Product Equality Declaration

We, Foxconn International Holdings Ltd., declare on our sole responsibility for the product of N139DL as below:

N139DL FCCID: (2AJOTTA-1398) and N139DL FCCID: (2AJOTTA-1451) are same performance from certification point of view.to implement 2nd IC for WLAN and BT

HW0201 PWB

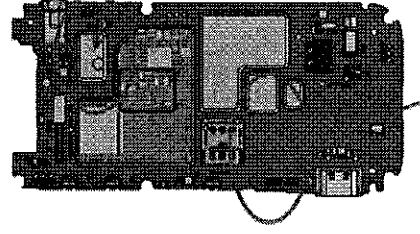
- HW change from FCCID 2AJOTTA-1398 to FCCID 2AJOTTA-1451 :
 - FM& SD card connector removed
 - WIFI & BT schematic design change, details refer to schematic of FCCID 2AJOTTA-1451. Page 35 change, and new add page 39.
 - WIFI & BT layout design change overview picture as below, HW0301 for FCCID 2AJOTTA-1398, HW0303 for FCCID 2AJOTTA-1451.

SD conn

HW0301 PWB

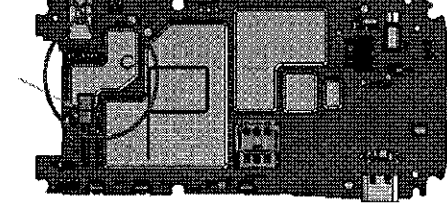
Wifi shielded

HW0303 PWB

Enlarge wifi shielding

Add new BT antenna feedpoint
